PIC32MZ Embedded Connectivity (EC) Family Silicon Errata and Data Sheet Clarification

The PIC32MZ Embedded Connectivity (EC) family of devices that you have received conform functionally to the current Device Data Sheet (DS60001191D), except for the anomalies described in this document.

2. Module: Primary Oscillator

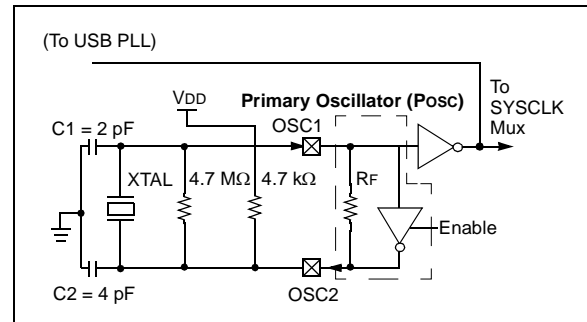
To use the Primary Oscillator with a crystal, only the following crystal is supported for PIC32MZ EC family devices:

XTAL = ABL5-LR-12.000MHZ-18-D-R-T

The following figure shows the required configuration.
